To	Annarie Boer (EPA)	Contact No.	
Copy to	Anne Price, Greg Phyffer	Email	
From	Tristan Sleight	Project No.	12627587
Project Name	North Kiaka Project		
Subject	Additional information to support the North Kiaka s40 (2)(a) Environmental Assessment 2346

1.2 Purpose of this Memorandum

The purpose of this document is to provide responses to the Requests for Further Information on Flora and Vegetation and Fauna to supplement the s40(2)(a) ERD. Comments were received from EPA Services, DCCEEW and DBCA.

Black Cockatoo Foraging Assessment

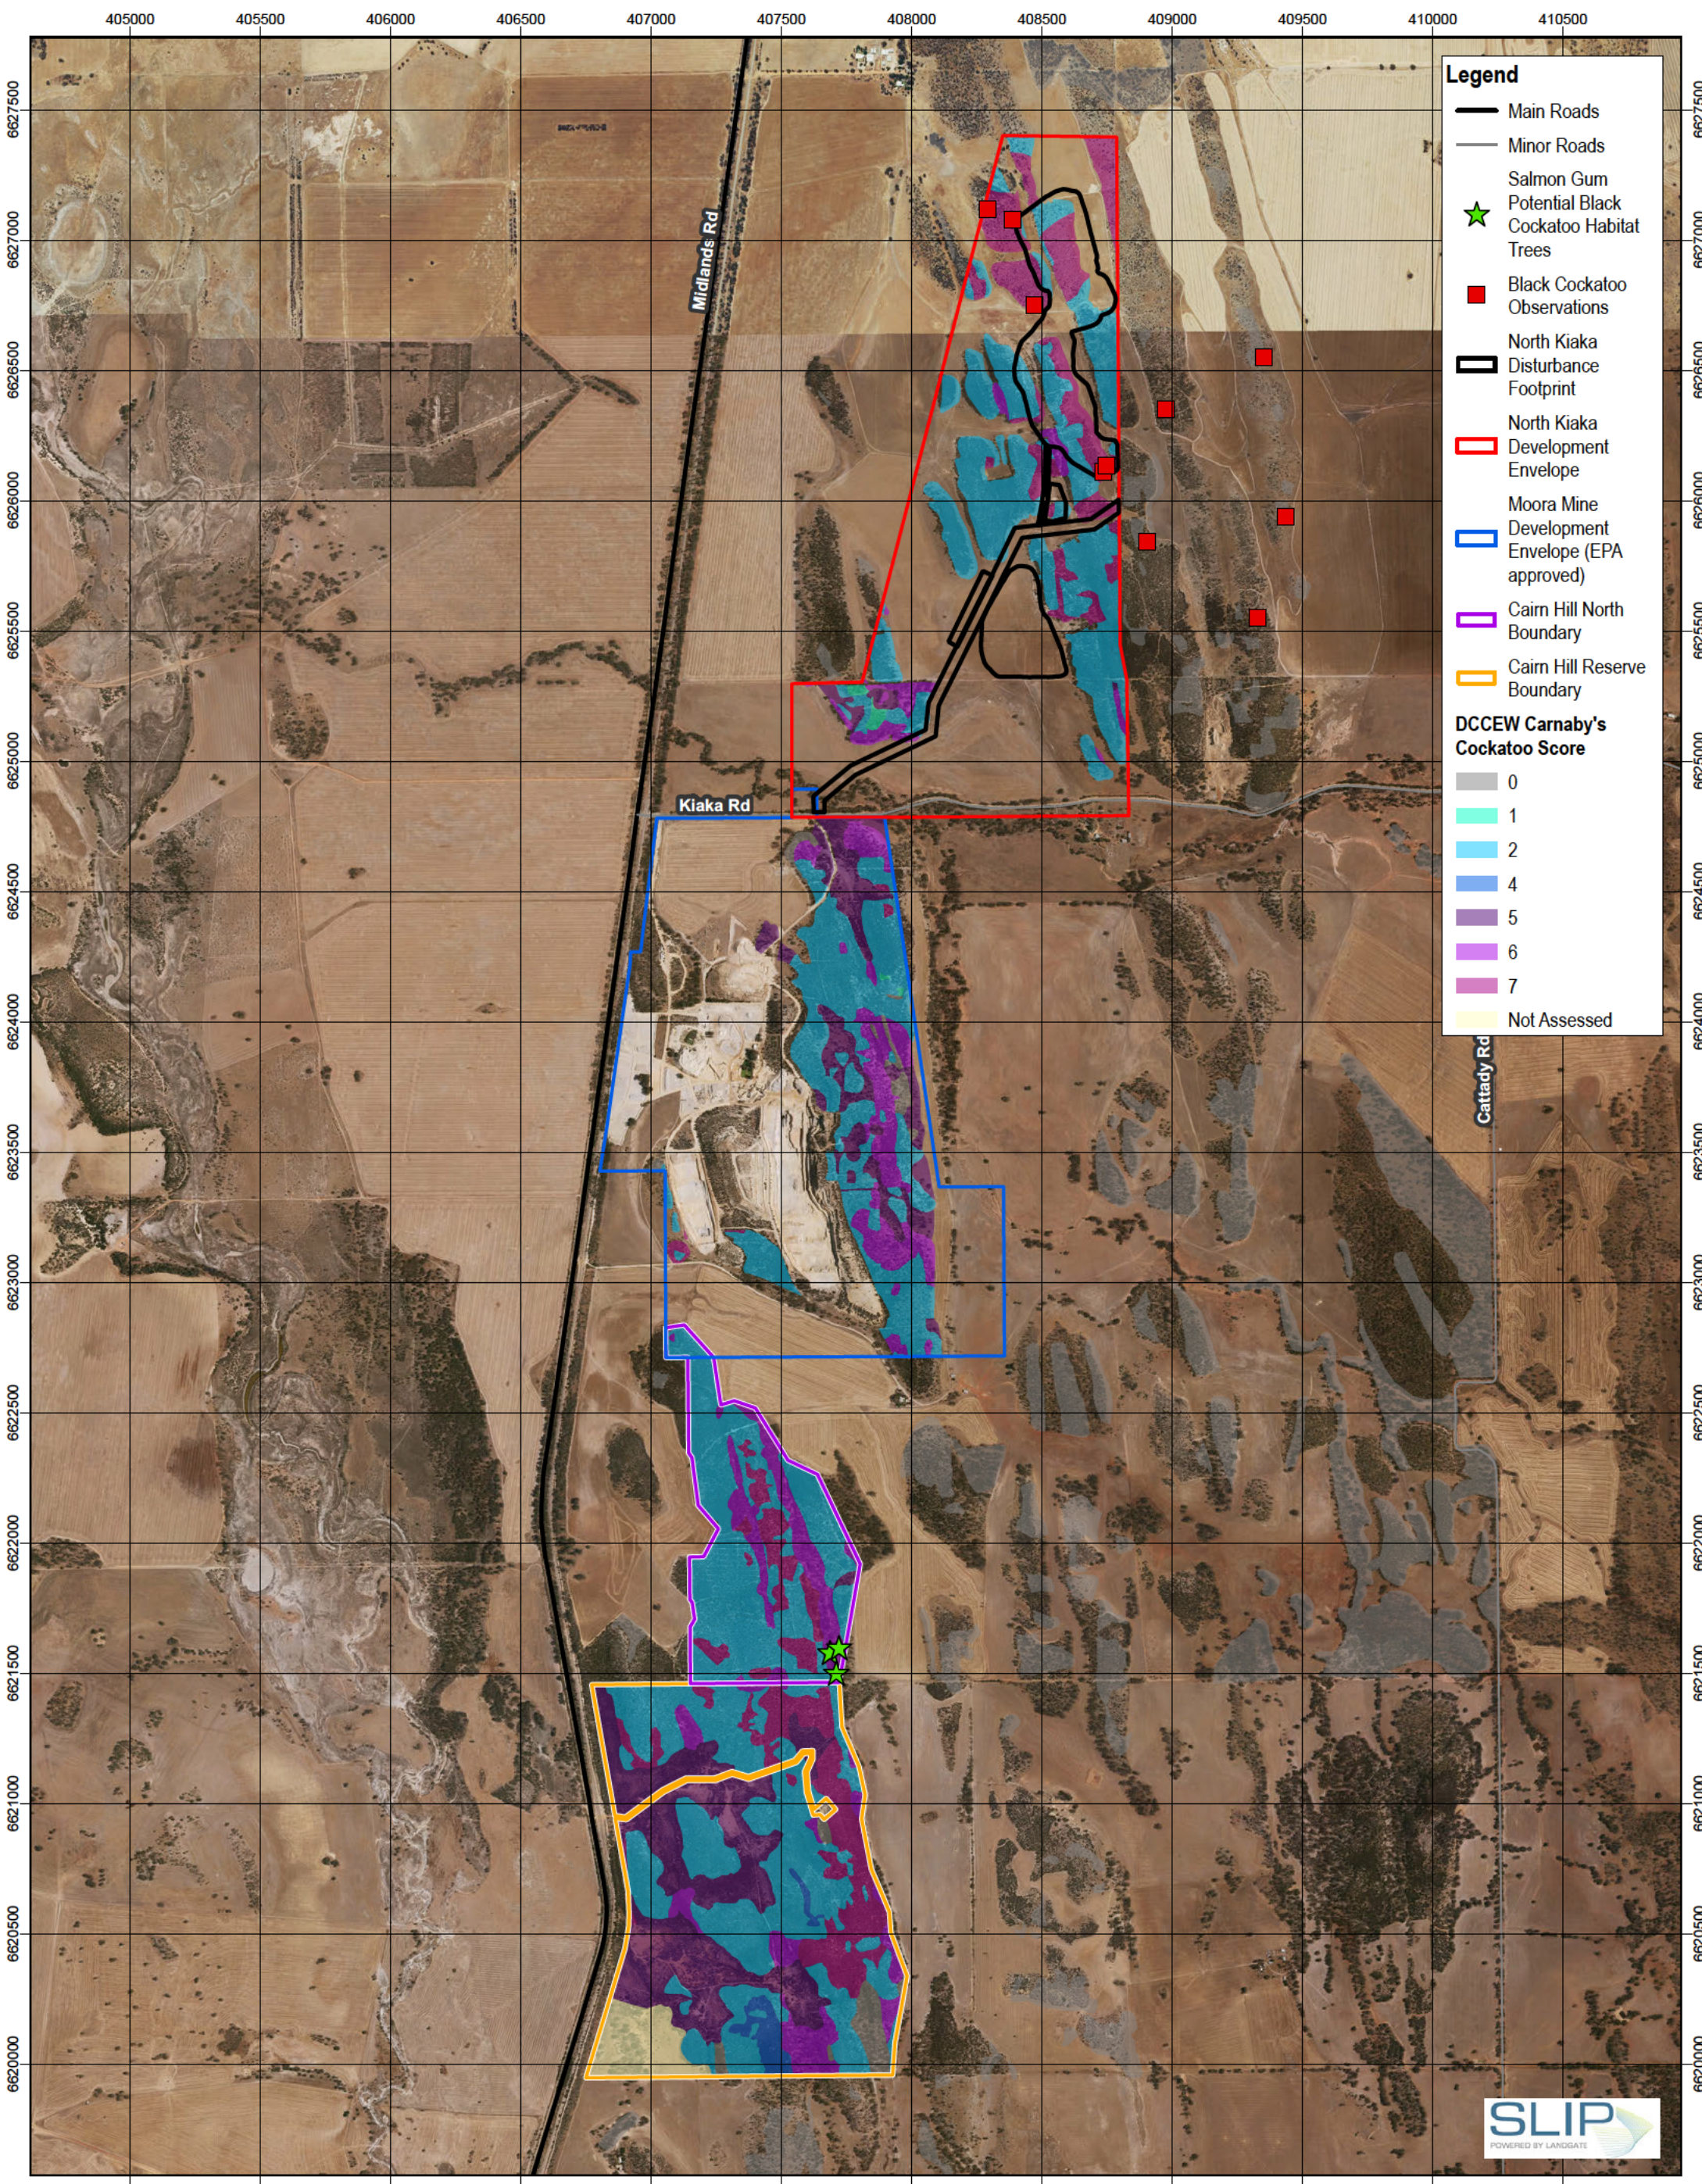
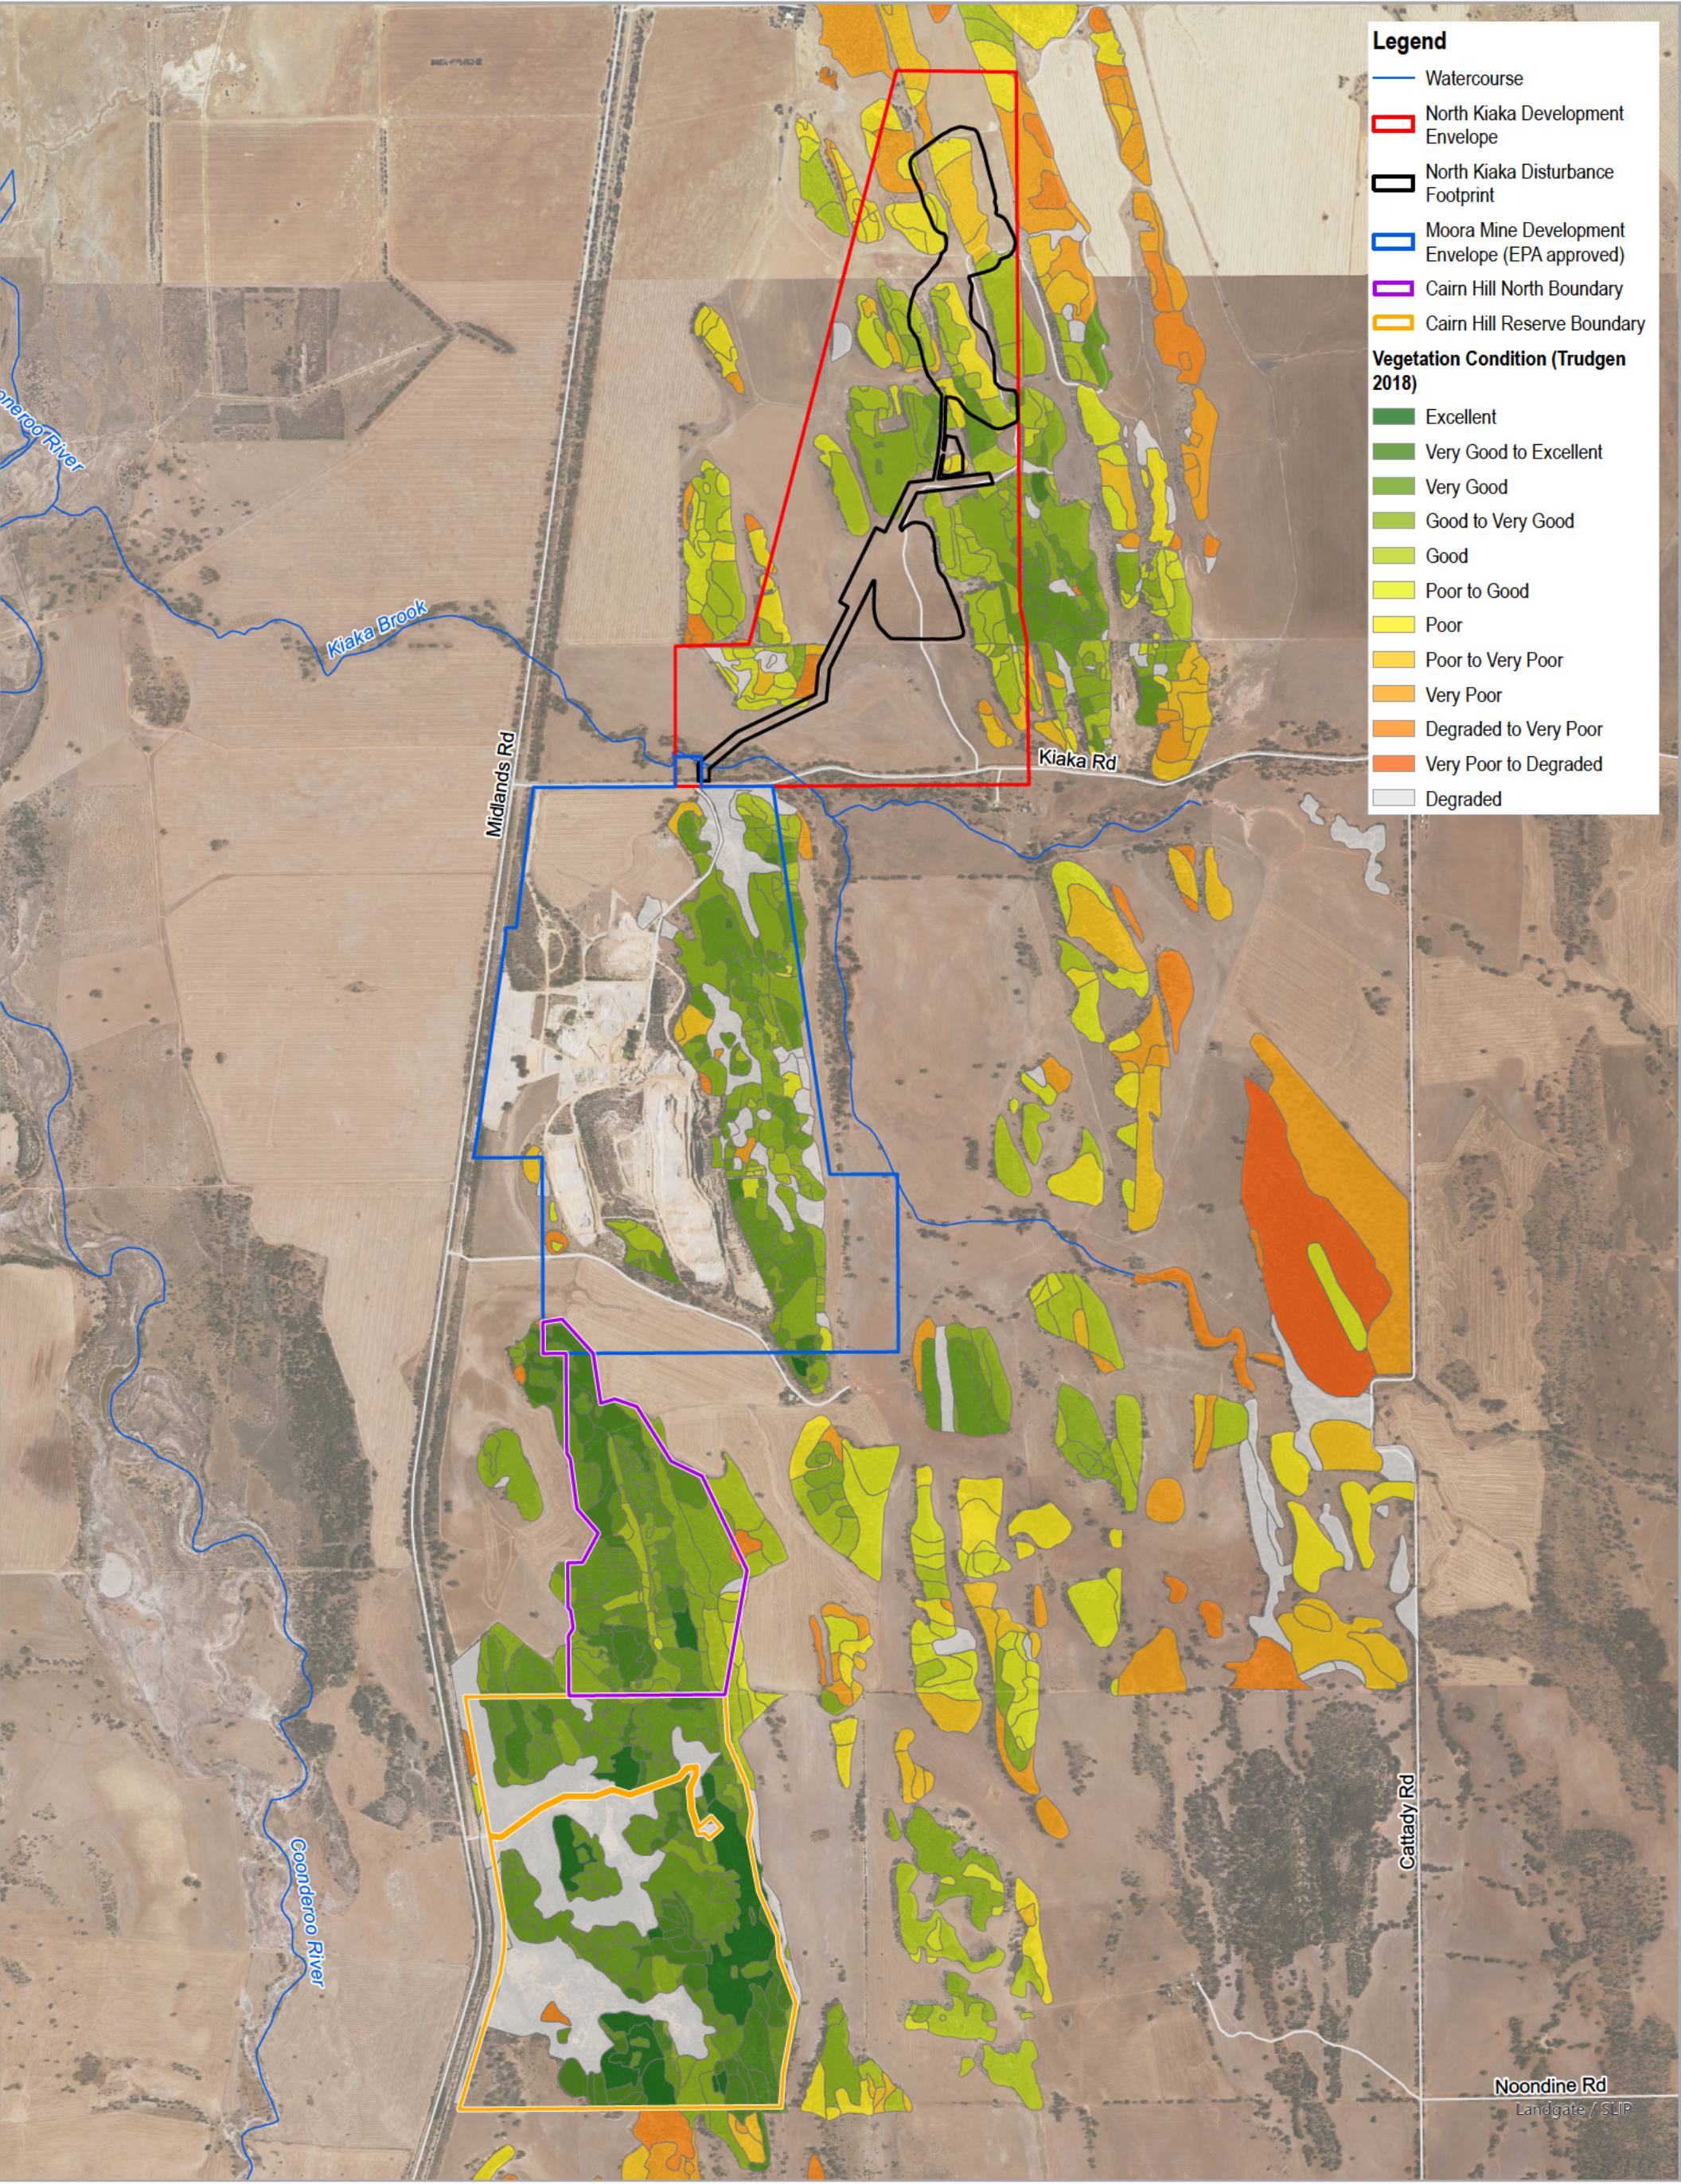
No.	Submitter	Advice or comments previously provided (14 August 2024)	Comment	Response January 2025
		<p><u>impact for CBC foraging habitat</u>. Please clarify this.</p> <p>The residual impacts to CBCs are inconsistently referenced throughout the documentation (both the hectare amount, and quality). Please ensure these impacts are consistently referenced.</p>		<p>which do not contain suitable values to be an offset. The areas not being considered could be rehabilitated with suitable species under the proposed measures in the draft OMP.</p> <p>The Offset Strategy and OMP have been prepared to meet the requirements of the current conservation advice</p> <ul style="list-style-type: none"> – Coomberdale Chert TEC: Threatened Ecological Community Fact Sheet: Vegetation alliances on ridges and slopes of the chert hills of the Coomberdale floristic region (DBCA, 2013). – Interim Recovery Plan 2013 – 2018, Interim Recovery Plan No. 338 – Heath dominated by one or more of <i>Regelia megacephala</i>, <i>Kunzea praestans</i> and <i>Allocasuarina campestris</i> on ridges and slopes of the chert hills of the Coomberdale Floristic Region (DPaW, 2013). <p>A calculation of the foraging values of the 18 ha set aside for Moora Mine has been included in Table 6. The offset area for Moora Mine impacts includes vegetation representative of the Coomberdale TEC and CBC foraging habitat. The offset area calculations have been made for the Moora Mine offset and the remaining areas which are available for North Kiaka. The remaining areas in Cairn Hill Reserve and Cairn Hill North for the North Kiaka impacts are included in Table 7 and Table 8.</p> <p>The OMP and Offset Strategy have also been amended to refer to the same calculations.</p> <p>This figure has been attached as Figure 4 in this Supporting Document.</p>

27	Maps	<p>Partially Met</p> <p>Please provide shapefiles and maps that show CBC habitat within the proposed action area and that are consistent with the Department's <i>Guide to providing maps and boundary data for EPBC Act projects</i>. These maps should make it clear which areas are proposed to be cleared as part of the action, and what the foraging value of these areas are.</p>	<p>All maps and figures need to incorporate coordinates – either in the form of standalone feature labels or by including a 'graticule' or 'grid' – to make the location of the project clear as outlined in the Department's <i>Guide to providing maps and boundary data for EPBC Act projects</i>.</p>	<p>SIMCOA confirms that all maps and figures in the relevant approval documents will be updated to meeting the Department's <i>Guide to providing maps and boundary data for EPBC Act projects</i>.</p> <p>These updated Figures will be provided in the Final Approval documents.</p> <p>Updated spatial data (.shp files) will also be provided.</p> <p>Figure 5 of this Supporting Document has been provided for DCCEEW's review that the Guide has been met.</p>
